Subject: RE: Request for revisions/considerations for final design (Epic wetland/waterway permit application)

Subject: Request for revisions/considerations for final design (Epic wetland/waterway permit application)

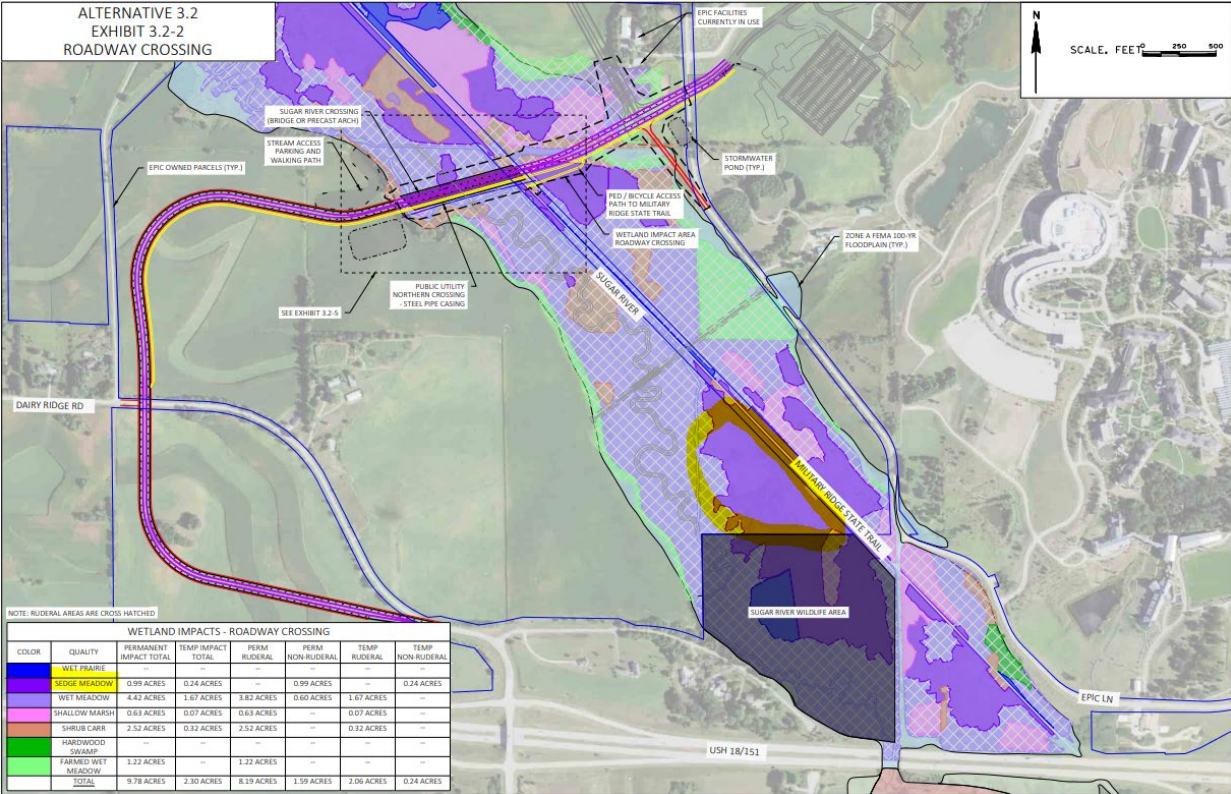
For #3, controlling for woody vegetation would include a level of monitoring and physical maintenance (removal of) woody species trying to establish. The woody vegetation within the higher quality sedge meadow community would, over time, change the nature of the plant community. It might be as simple as an annual review of this specific plant community to identify/flag woody vegetation and then removal of those individuals to maintain the sedge meadow community type. I checked the wetland plant community mapping (from the alternatives analysis maps) and believe the specific sedge wet meadow being referenced is what I have highlighted in the image below:

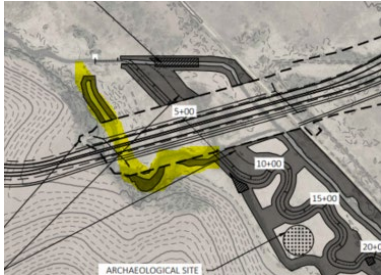
2. Revision request for stream restoration design
 - a. There was information brought to our attention about existing springs located on the west side of the river valley at the approach for the bridge. This section (highlighted in yellow in the image below) was not included in the stream restoration but there is concern that existing active springs would be significantly impacted by the construction of a bridge and abutment.

- i. **Next steps:** Please provide a map identifying the springs and a revised restoration (realignment) design to include the active springs and the flow to be incorporated into the restoration. If the springs are located completely south of the proposed abutment, then identifying the springs is needed on an updated plan map showing a flow path to ensure the flow from the springs will reach the new realigned stream channel. If the springs are located north of the proposed abutment, then the stream restoration will need to accommodate and incorporate the springs and flow (which likely requires bridge design adjustments) to ensure the springs remain open and are part of the river system.
